## CITY OF GLENDALE, CA

### DESIGN REVIEW STAFF REPORT – COMMERCIAL / INDUSTRIAL / MIXED USE

<b>August 10, 2023</b> <i>Hearing Date</i>	<b>1900 Riverside Drive</b> <i>Address</i>
<b>Design Review Board (DRB)</b> <i>Review Type</i>	<b>5625-031-008</b> <i>APN</i>
<b>PDR-000210-2022</b> <i>Case Number</i>	<b>Richard Dell, RED Architecture</b> <i>Applicant</i>
<b>Vista Ezzati</b> <i>Case Planner</i>	<b>Rene Karapedian, PRI Properties, LLC</b> <i>Owner</i>

PROPOSED SITE PLAN  
SCALE: 1" = 20' - 0"

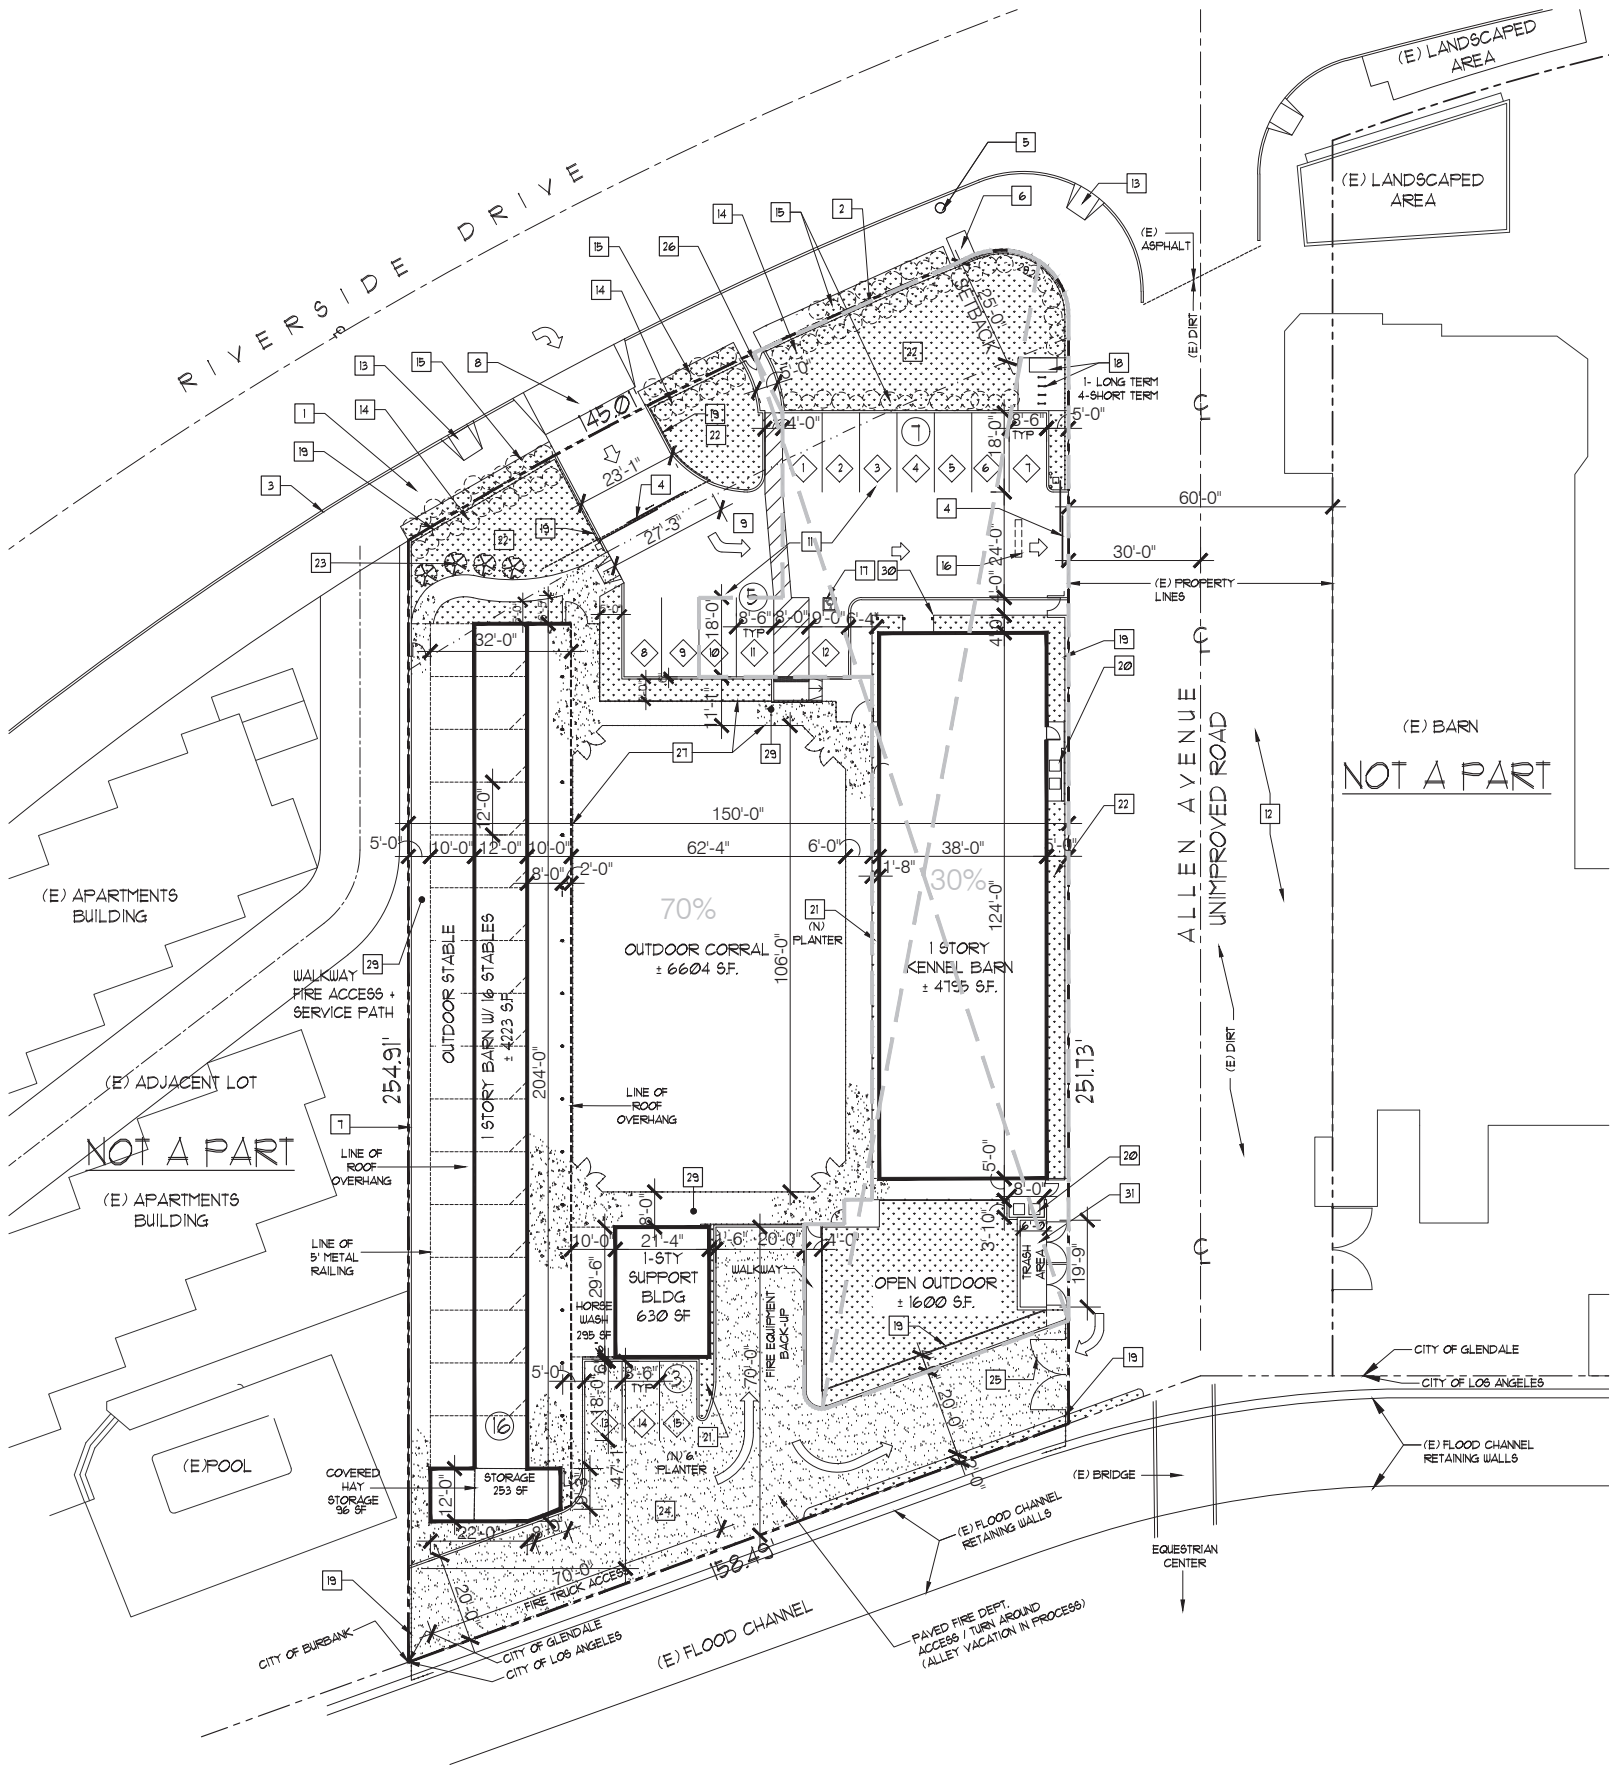
The drawings indicate that the existing asphalt parking area at the front will be maintained, the new parking area at the rear will feature new stamped concrete paving, and the pedestrian walkways will be concrete. No other information is provided on the plans about these areas. Staff is recommending a condition of approval that the parking areas and pedestrian walkways be redesigned to include decorative paving materials with consideration given to permeable paving options to help reduce stormwater runoff.

As discussed in the site planning section, staff is recommending a condition of approval that the parking areas and pedestrian walkways be redesigned to include decorative paving materials with consideration given to permeable paving options to help reduce stormwater runoff.

WINDOW AND DOOR SCHEDULES  
FOR ALL BUILDINGS AND STREET VISIBLE  
WINDOW PROFILE DETAIL  
DESIGN REVIEW

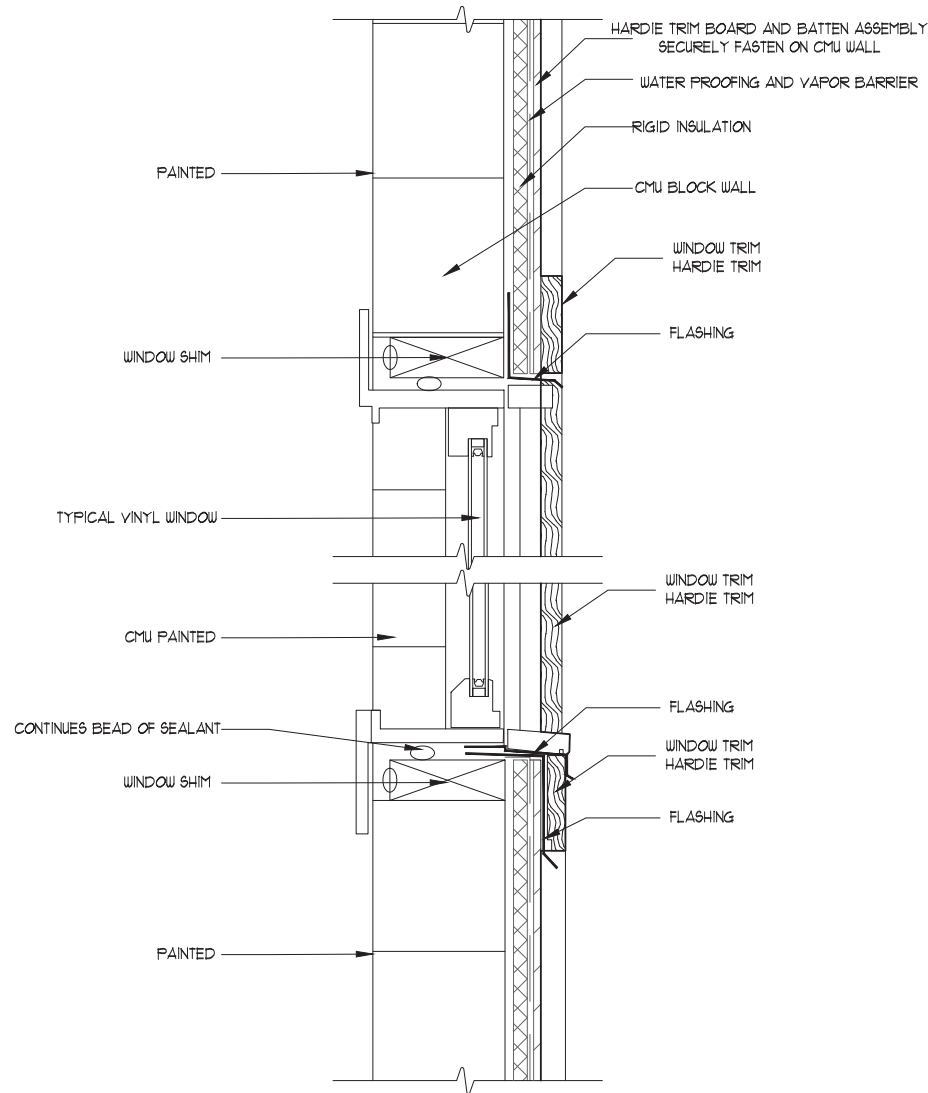
This project is proposing black vinyl windows with external grids. In the past, the Board has allowed some residential projects to feature colored vinyl windows based on a case-by-case basis. Staff recommends that the window material be revised to be of a higher quality, such as fiberglass or wood, though the Board can consider allowing the window material to remain vinyl, based on past determinations for some residential projects. The frame type (e.g., block frame, nail-on) and edge details for the new windows are not identified on the window schedules and details. A staff recommended condition of approval will require the window schedules to be revised to identify the window frame type and edge details, and vertical and horizontal window section details to be provided that illustrate the installation, recess, sill, and frame for the different window types, and external grids as applicable.

1. The applicant shall obtain approval of an Alley Vacation prior to the issuance of a building permit.
2. The window material shall be revised to a higher quality material such as fiberglass or wood with the window frame type identified in the schedule.

3. The window frame type and edge detail shall be identified on the window schedules with vertical and horizontal window section details provided for each window type that shows recess, sill, and frame, and external grids as applicable.

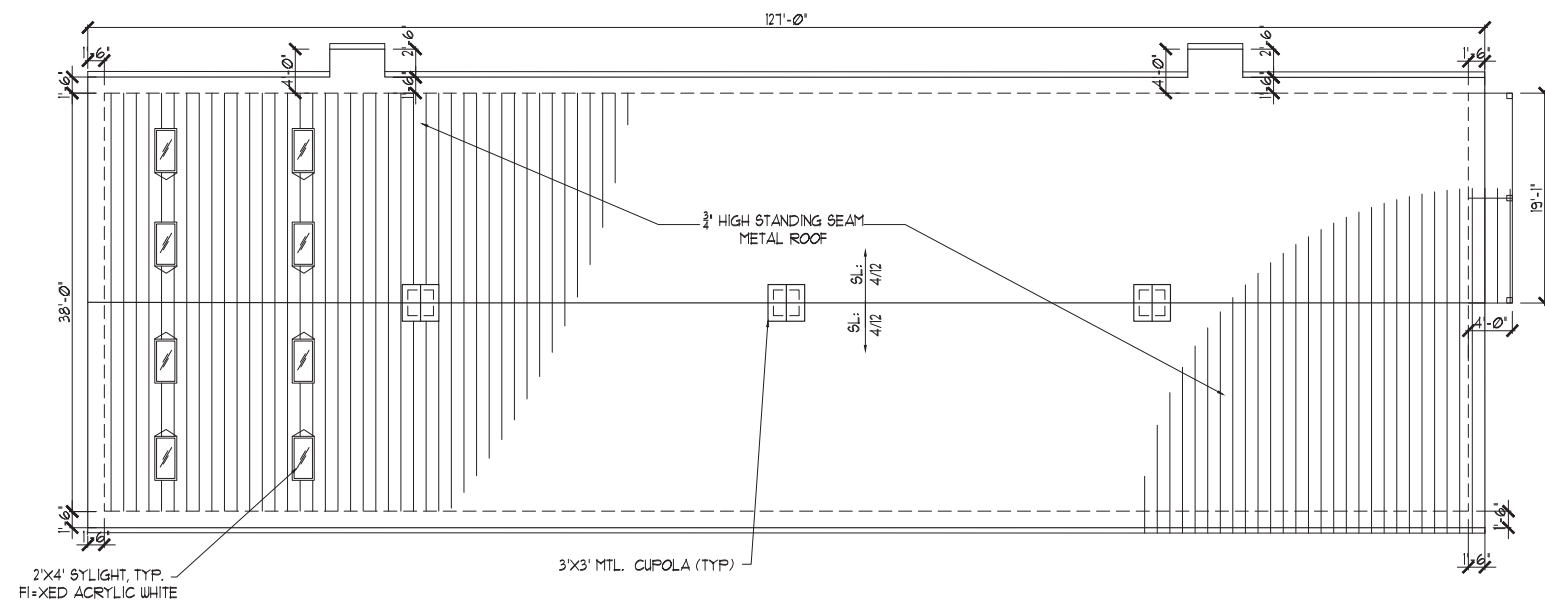
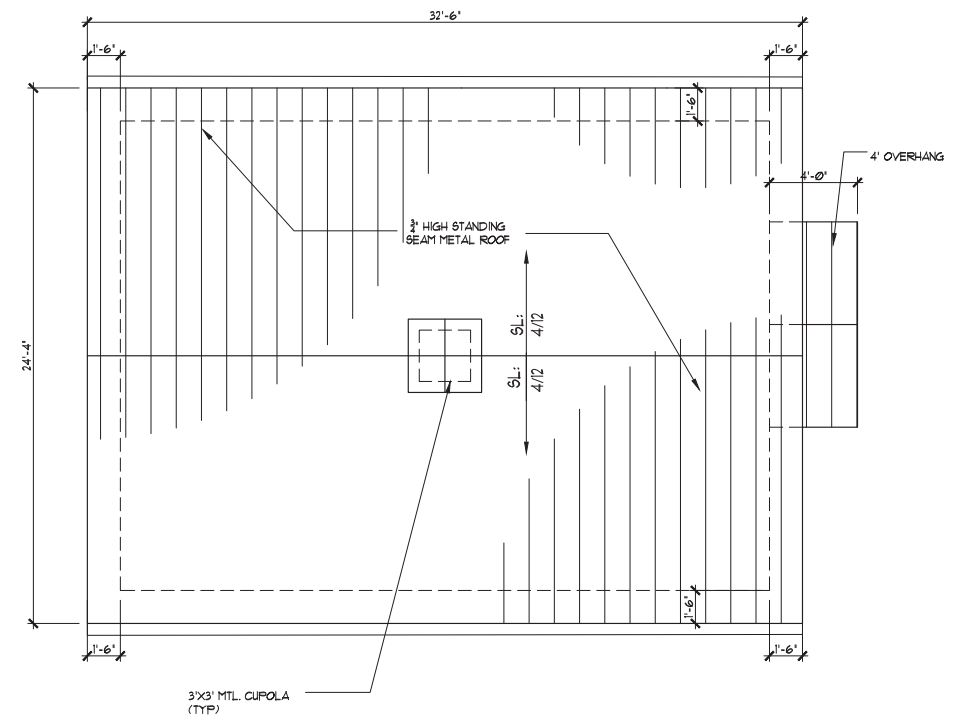
As noted above, staff is recommending conditions of approval related to the window material and detailing. The drawings also identify new vinyl cupolas, where high-quality materials are encouraged by the design guidelines. As such, a staff recommended condition of approval will require this to be revised. Additionally, the drawings do not illustrate how the cladding will wrap the corners (e.g., mitered, corner board, etc.). Staff is recommending a condition of approval that corner details be provided.

6. The applicant shall provide corner details that illustrate how the different cladding wraps the building corners.
7. The proposed vinyl cupolas shall be revised to a higher quality material such as wood or metal.
